Access Compliance Report

Public Rights-of-Way

(Curb Ramps)

Intersection ID: 5518	Main Street: MISTY_VALE_RD	Cross Street: NORTHWOODS_FOREST_DR	Location: NW
ADA ID: 42651AE8C946	Ramp Type: Perp	Initial Pass/Fail: Fail	Overall Compliance: No
		Severity Score: 12.5

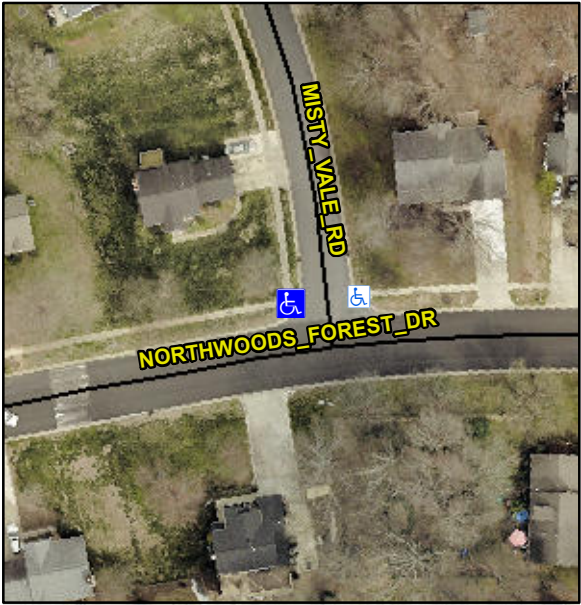
Codes/Mitigation Info/Possible Solution		Field Measurements/Component Compliance					
	Possible Solutions:						
	Remove & Replace Entire Ramp.	N/A	Ramp Length (in)	70.0	Yes	Ramp Slope (%)	7.4
		Yes	Ramp Width (in)	62.0	No	Ramp XSlope (%)	5.1
		N/A	Flare Type LT	N/A	N/A	Flare Type RT	N/A
		N/A	Flare Slope LT (%)	N/A	N/A	Flare Slope RT (%)	N/A
		N/A	Flare Traversable LT?	N/A	N/A	Flare Traversable RT?	N/A
		N/A	Landing Length (in)	N/A	N/A	DWS Provided?	N/A
		N/A	Landing Width (in)	N/A	N/A	DWS Contrast?	N/A
		N/A	Landing Slope (%)	N/A	N/A	DWS Length (in)	N/A
		N/A	Landing X Slope (%)	N/A	N/A	DWS Full Width?	N/A
		N/A	Landing Curb? (Y/N)	N/A	N/A	DWS Offset (in)	N/A
		N/A	Shared Landing?	N/A			
		N/A	Gutter Ponding?	N/A	N/A	Gutter Slope (%)	N/A
		N/A	Gutter Lip Ht (in)	N/A	N/A	Gutter X Slope (%)	N/A
		N/A	Painted X Walk1?	No	N/A	Painted X Walk2?	N/A
			X Walk 1 Direction	To E		X Walk 2 Direction	N/A
		N/A	X Walk 1 Width (in)	N/A	N/A	X Walk 2 Width (in)	N/A

X Walk 1 Slope (%)	4.7		X Walk 2 Slope (%)	N/A
			X Walk 1 X Slope (%)	2.1		X Walk 2 X Slope (%)	N/A
		N/A	Ramp inside XWalk1?	N/A	N/A	Ramp inside XWalk2?	N/A
<p>Surveyor Notes:</p> <p>N/A</p> <p>PROW/ADA:</p> <p>Not Found, R304.5.3</p>			Road Slope (%)	N/A	N/A	Clear Space?	N/A
			Road X Slope (%)	N/A	N/A	Clear Space to XWalk (in)	N/A
		N/A	Any Obstructions?	N/A	N/A	Storm Grate/Utility Hazard?	N/A
			Obstruction Type			Storm Grate/Utility Type	
					N/A		N/A
					Yes	Surface Condition? (G/P)	Good
Total Cost:		\$	1850.00
